Subject ▶ Addition of Rubber Pin 4

For Models ▶ 8413D, 8433D, 8443D

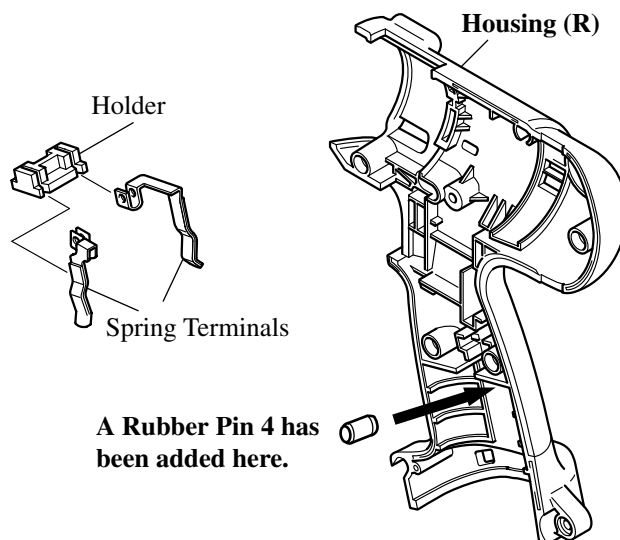
Description ▶ For tighter contacts of battery terminals with spring terminals in housings, a Rubber Pin 4 (Part. No. 263024-9) has been added to each of Housings (R) and (L). The new Motor Housing Set comes with a couple of Rubber Pins.

1. Interchangeability mark ; ← means that the new part is substituted for the current.
2. New Motor Housing Set for replacement does not have a Makita logo engraved in its side, so it has a Makita logo label adhered to its side instead.
3. Current Motor Housing Set accepts the Pin 4 as well as New Motor Housing Set.
